UNITED STATES PATENT AND TRADEMARK OFFICE

APPLICATION NO.	FILING DATE	FIRST NAMED INVENTOR	ATTORNEY DOCKET NO.	CONFIRMATION NO.
10/773,787	02/06/2004	Sanjay Shah	GOLDSTAR 3.0-007	7914

Office Action Summary	Application No.	Applicant(s)	
	10/773,787	SHAH, SANJAY	
	Examiner	Art Unit	
	David C. Reese	3677

DETAILED ACTION

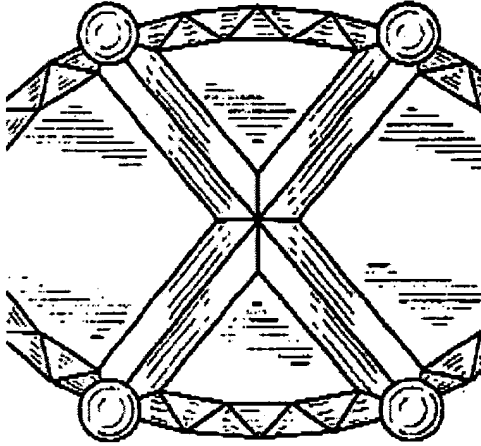
Continuing on to the applicants specific rebuttals beginning with the statement that there is no teaching in the Chan design patent that its multi-stone jewelry setting has first and second crossbar members that form an X shaped configuration for its prong setting. This is true, Chan's

design patent does indeed not teach of first and second crossbar members. Chan, as prior art, however, was not used for the purpose of showing such a feature. Gurevich is the fundamental prior art with respect to the first and second crossbar members as his patent teaches of such the ability to use crossbar members for supporting up to six gemstones. The purpose of the crossbars of Gurevich was to show that one could easily consult the reference of Gurevich and substitute such a crossbar feature into any given jewelry setting. And since in Gurevich, the crossbar members are directly representative to the position and number of prong members, one can easily surmise that if one were to input crossbar members in the jewelry setting of Chan, they would form a X configuration due to the position of the prong members of Chan. Continuing on to the latter argument surrounding Gurevich and how applicant believes that he does not show of an X shaped configuration for its prong setting. Claims in a pending application should be given their broadest reasonable interpretation. *In re Pearson*, 181 USPQ 641 (CCPA 1974). With such reasoning, it is easy to interpret the structure of Gurevich shaped as an X. 50 in the figures just happens to be the center of the X crossbar. It is without a doubt a matter of art recognized equivalence, as incorporating such a feature would be readily apparent to one skilled in the art. To further prove the equivalence of such a feature, examiner would also like to point out Benderly, US-D334,154; wherein in Fig. 10, another example of such a X-shaped configuration for crossbar members is shown.
